# CHAPTER V

## Other CEQA Considerations

# Transit Center District Plan and Transit Tower Case No. 2007.0558E and 2008.0789E

***Comment AE-7: Is the proposed project at 8 Washington Street included in the cumulative scenario photomontage from Treasure Island?***

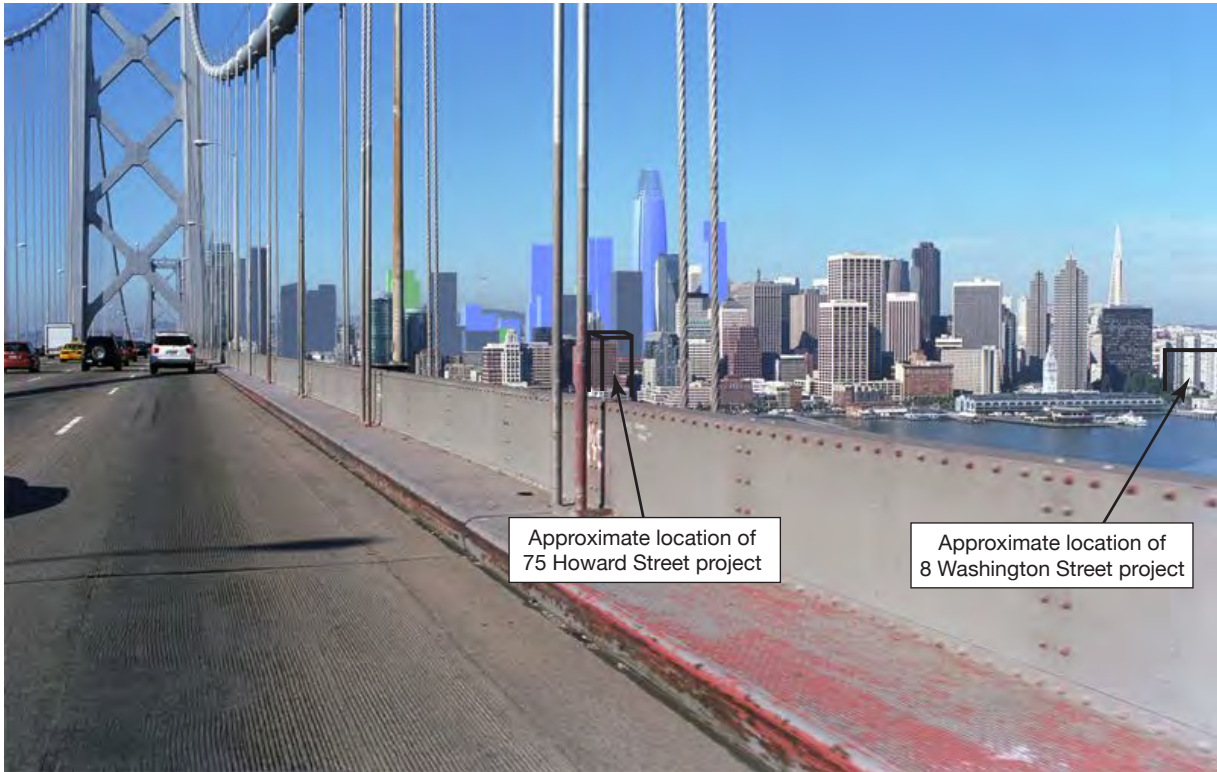
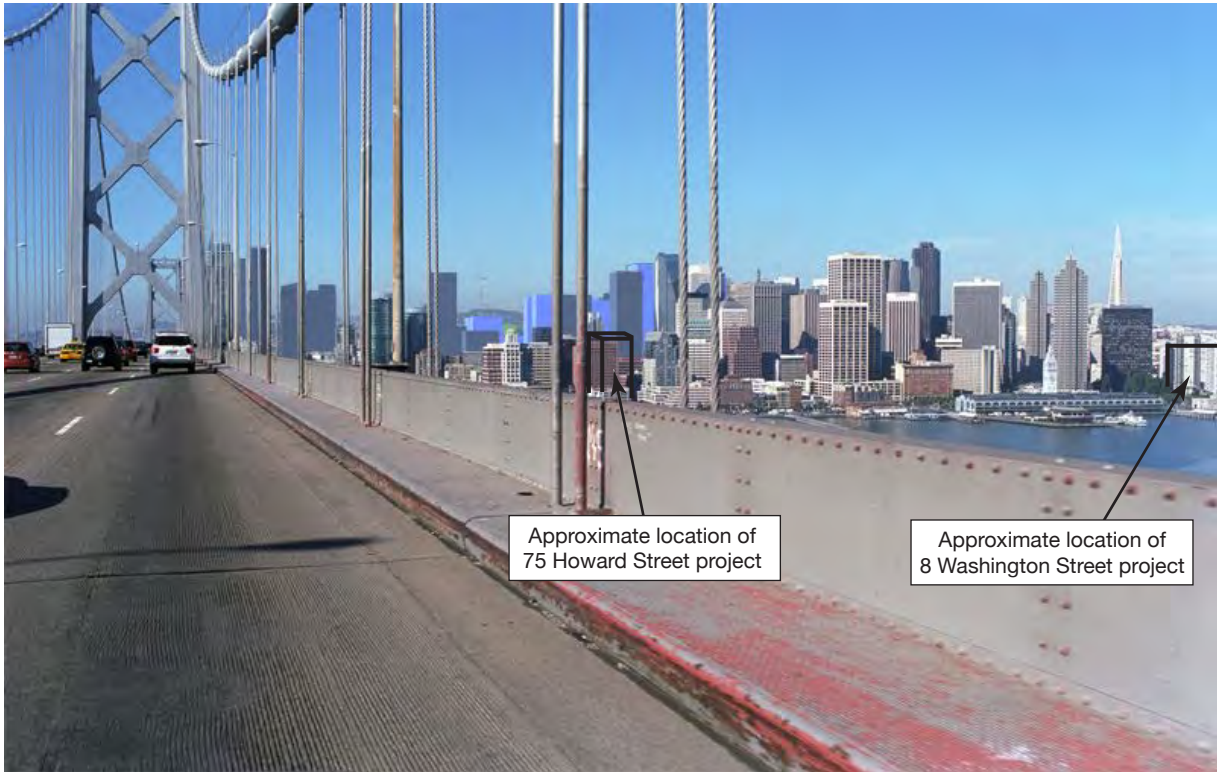
*“Does cumulative development one from T.I. include the proposed 8 Washington project?” (Sue Hestor, on behalf of SFRG)*

The project at 8 Washington Street (Case No. 2007.0030E, Final EIR certified and project approved by the Planning Commission on March 22, 2012) is not shown in the visual simulation from Treasure Island (EIR Figure 39B, p. 150), which depicts potential development in the Plan area and nearby cumulative towers. The 8 Washington Street project, which would be up to 136 feet in height, is proposed for a location approximately 2,200 feet (0.4 miles) northeast of the proposed Transit Tower site, and equally distant, or farther, from any location in the Plan area proposed for an increased height limit. Because Treasure Island is northeast of the Plan area (its southernmost location is at approximately the same latitude as the Municipal Pier at Aquatic Park), the view in Figure 39B is looking southwest. In this view, the 8 Washington Street project would be nearly indistinguishable against the immediate backdrop of the four 22- to 25-story residential buildings of Golden Gateway Center and the 27-story, 398-foot-tall office building at One Maritime Plaza (the former Alcoa Building). Even from the Bay Bridge, closer to San Francisco, as shown in EIR Figure 40B, p. 152, the proposed 8 Washington Street project would not result in a substantial adverse change in views. **Figure C&R-3** illustrates the approximate location and size of the approved 8 Washington Street project from this viewpoint, using a “wire-frame” model to demonstrate the generalized massing of this project. Therefore, the 8 Washington Street project would not combine with potential future development in the Plan area to result in a significant cumulative impact in views from Treasure Island.

Also not depicted in the cumulative visual simulation from Treasure Island (EIR Figure 39B) is a recently proposed project at 75 Howard Street, discussed in the response to Comment PD-1, p. C&R-18. As noted in that response, no application was on file for this building at the time the Draft EIR was published. This building would be approximately the same height as the Rincon Center towers across Howard Street, but would be taller than buildings west of it. However, in the cumulative scenario, as with 8 Washington Street, this building would largely blend in against proposed or anticipated buildings behind it in the view from Treasure Island. In the

**● Figure 64 (revised)**  
 Maximum Extent of New Shadow on Portsmouth Square

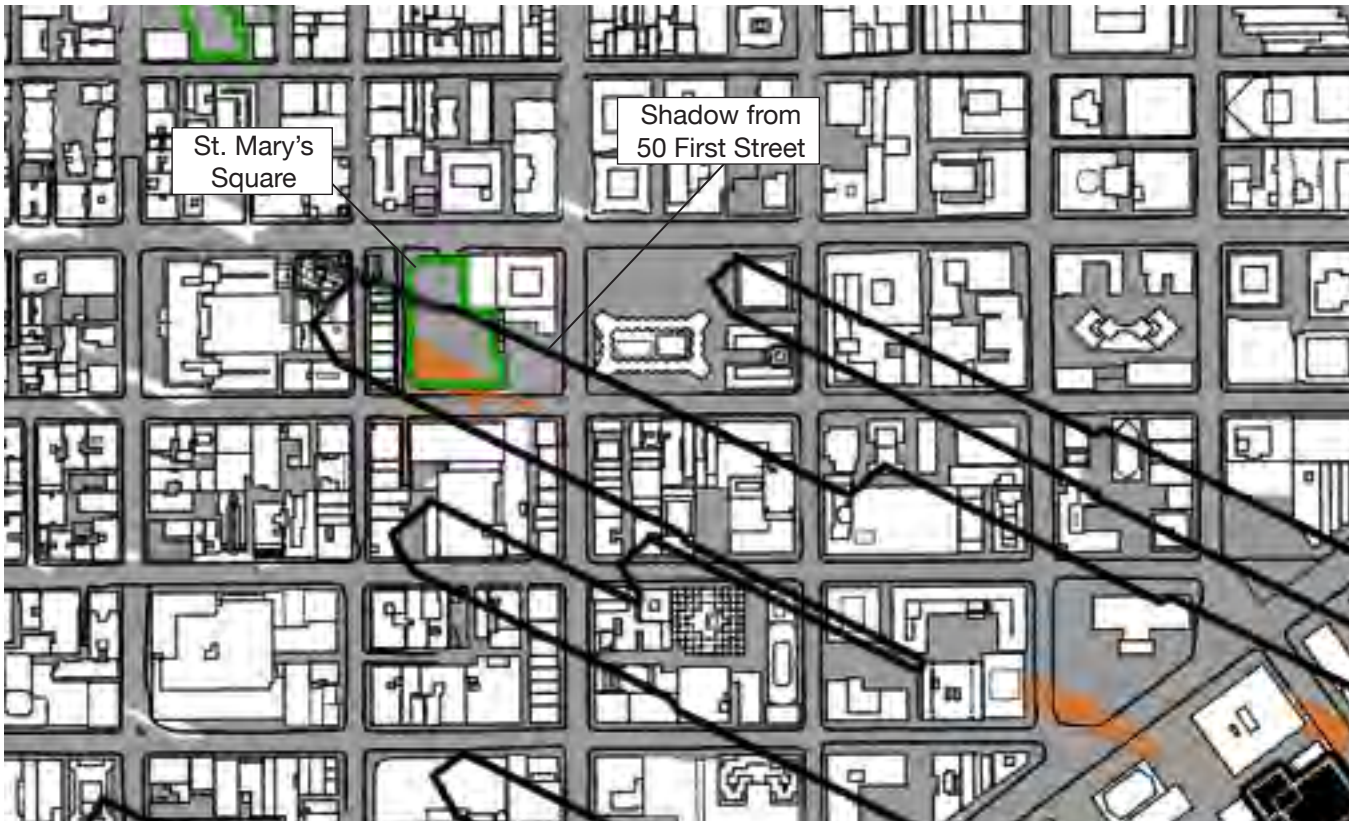
It is noted that the DEIR included two graphics in the shadow analysis which incorrectly presented the same figure, of draft Plan impacts, twice and did not depict Transit Tower shadow. Accordingly, EIR Figures 64 and 65, pp. 512 and 514, have been revised to depict maximum shadow from the proposed Transit Tower alone on Portsmouth Square and St. Mary's Square, respectively. The revised figures are included in this Comments and Responses document at the end of Section E, Revisions to the Draft EIR, following p. C&R-139.

"As p. 524 of the DEIR states, 'The greatest one-time effect would be on Portsmouth Square. The Transit Tower would add about 22,500 sq ft of shadow, covering about 35% of the park, at 9:15am in early November and late January.' Figure 64 (p.512) shows that the maximum extent of new shadow on Portsmouth Square will cover the portion of the upper level of Portsmouth Square that currently provides the greatest amount of open space. This specific area is the primary open-air 'plaza' of the park and is often used for tai chi, exercising, and the stage area for cultural events in this neighborhood.

On pages 512 and 514, Figures 64 and 65 are revised to depict maximum shadow from the proposed Transit Tower alone on Portsmouth Square and St. Mary’s Square, respectively. (The revised figures appear following p. C&R-139.)
